**M54 to M6 Link Road
TR010054**

**8.8 LIU(E) Draft Statement of Common
Ground with Mark Commins & Tracey
Commins**

STATEMENT OF COMMON GROUND

Appendix B – Fencing drawing

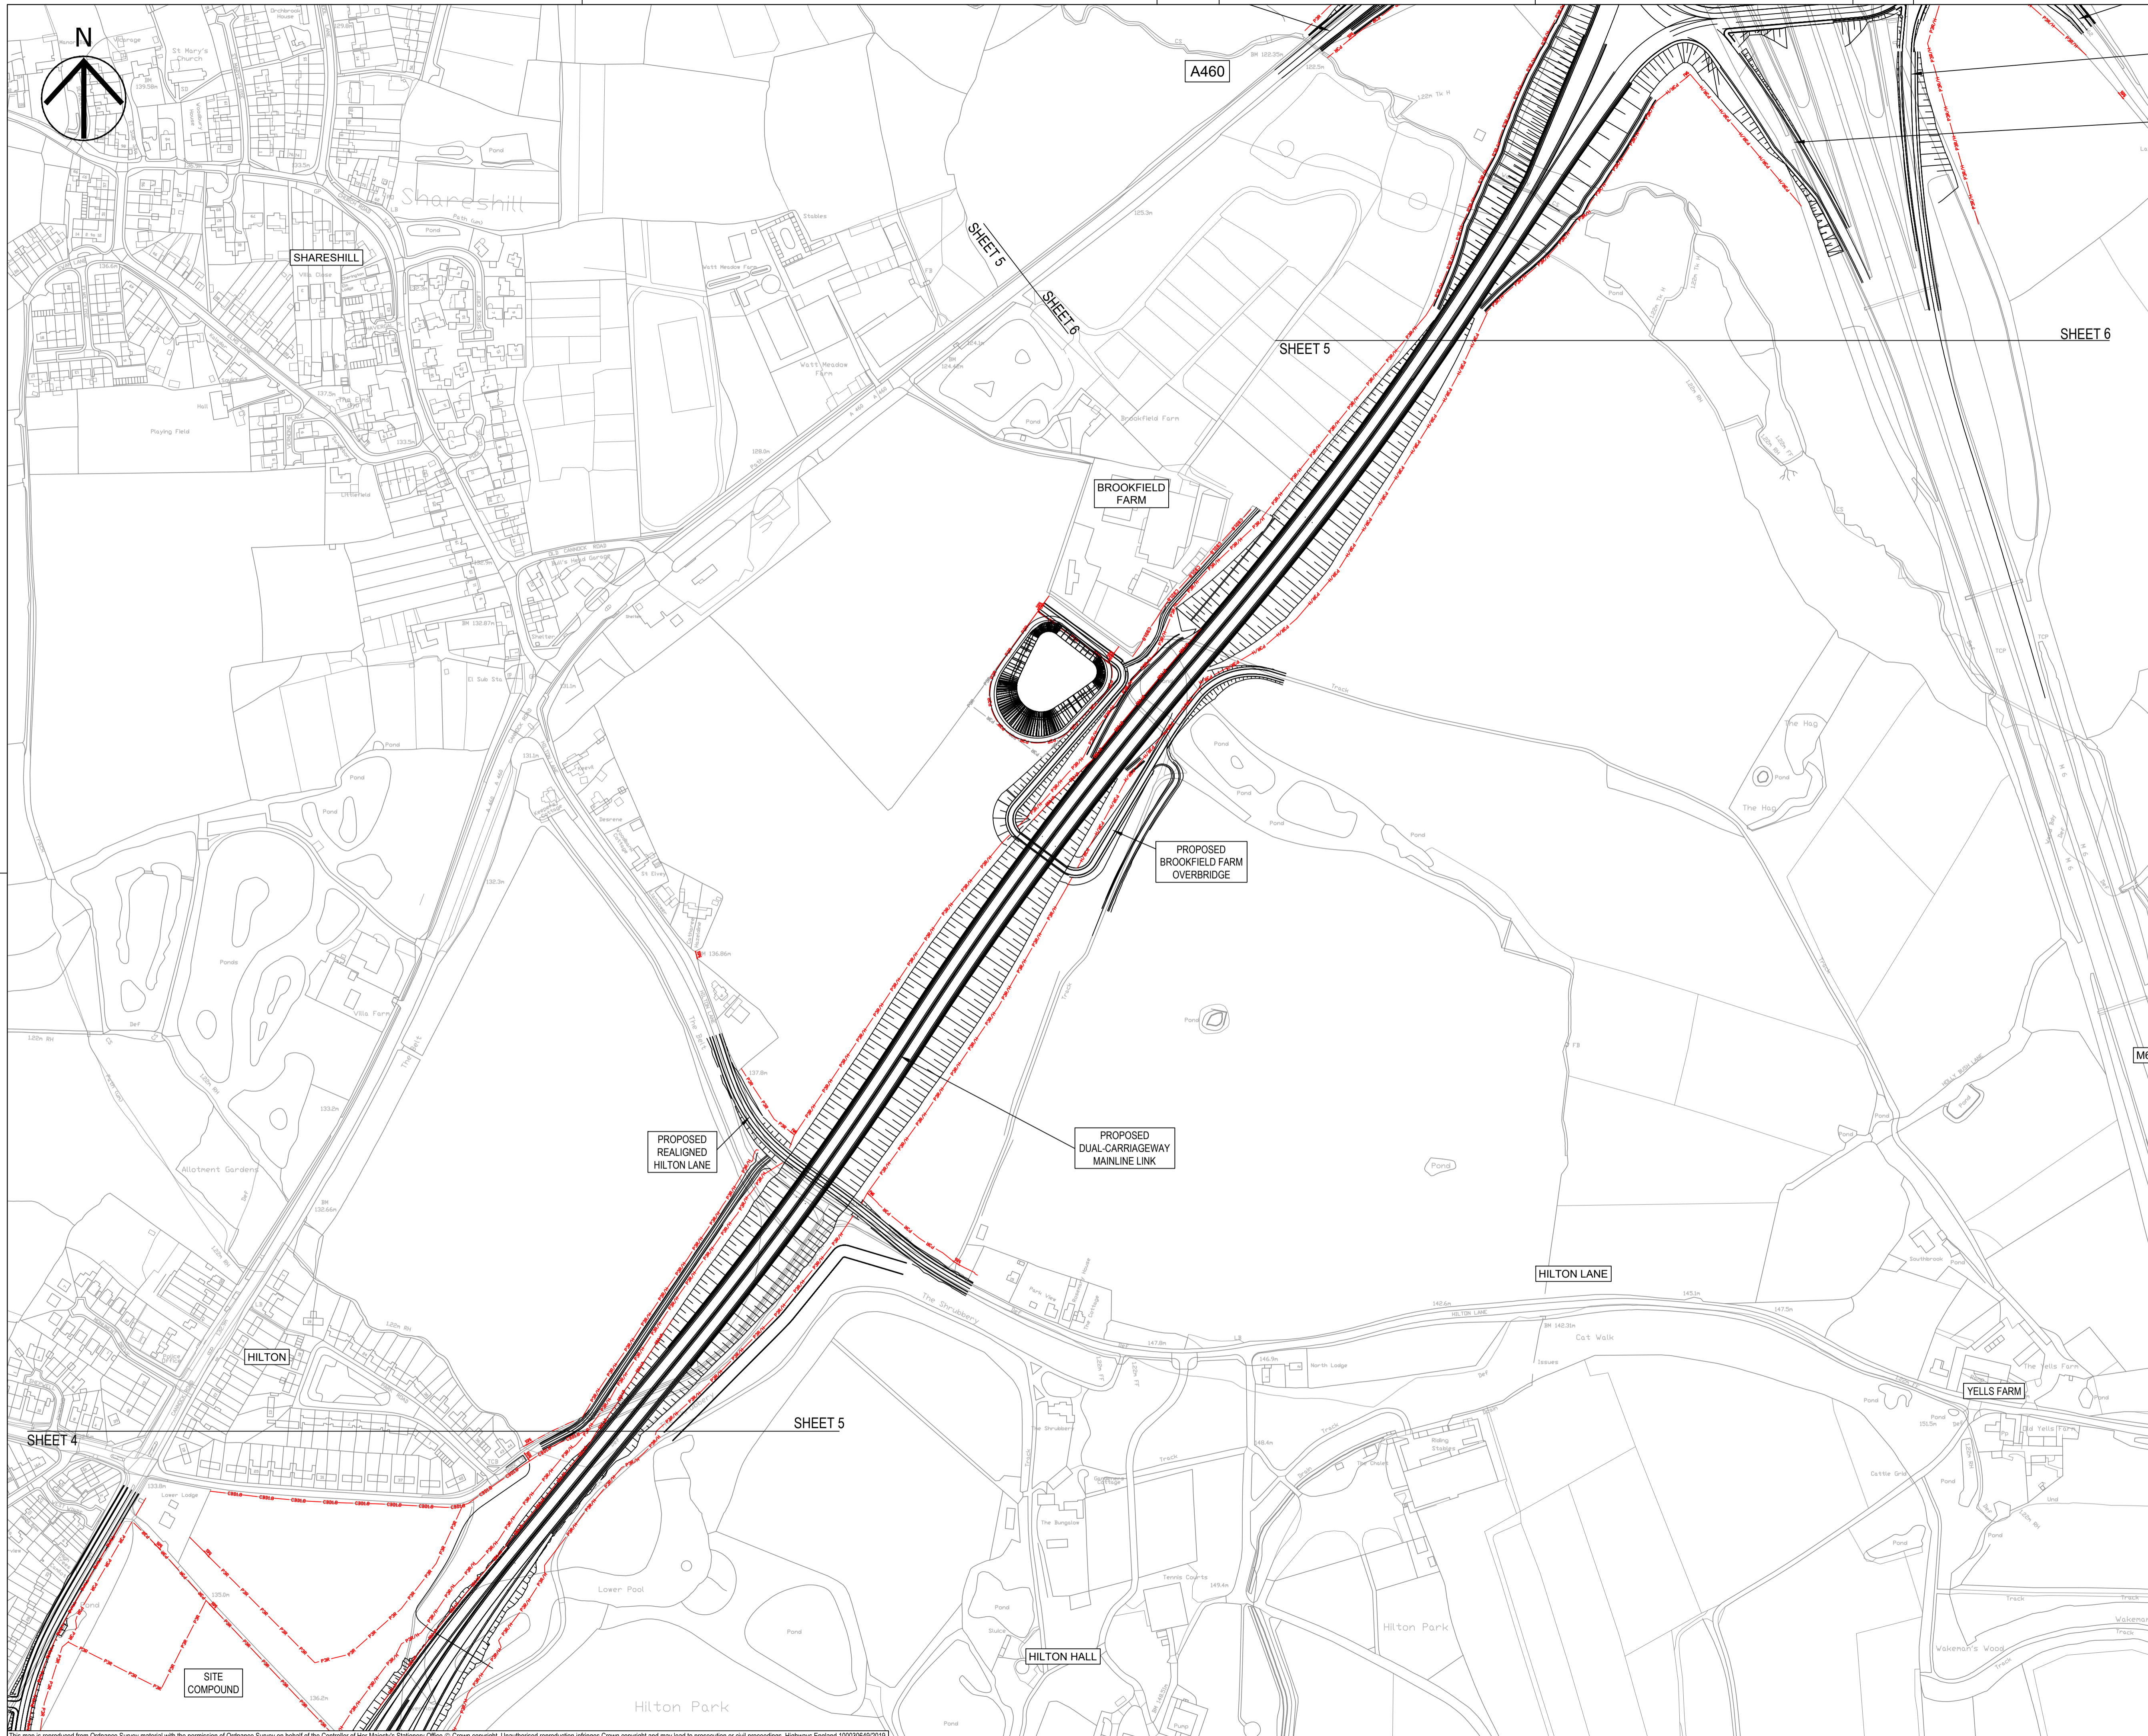
Issue	Landowner comment	Highways England Response	Status	Agreement likely ¹
		Highways England will continue discussions with this Landowner.		
Water supply to Brookfield Farm	Current mains water supply comes from Hilton Lane.	<p>Highways England will be conducting a utility survey within the early months of 2021 to ascertain the presence of the underground spur. We would need to trace the underground supply alignment to determine if it is impacted by the works adjacent to Brookfield Farm Overbridge.</p> <p>If the said supply is impacted, Highways England would look to provide a localised diversion.</p> <p>Should the supply be unaffected by the proposed works, an alternative supply would not be provided.</p> <p>Highways England will continue to engage with the landowner and provide a further update once the utility survey is complete.</p>	Agreed (To be confirmed by landowners)	High
Articles and Requirements	The landowners do not have any comments on the Articles or Requirements on the draft DCO.		Under discussion	High
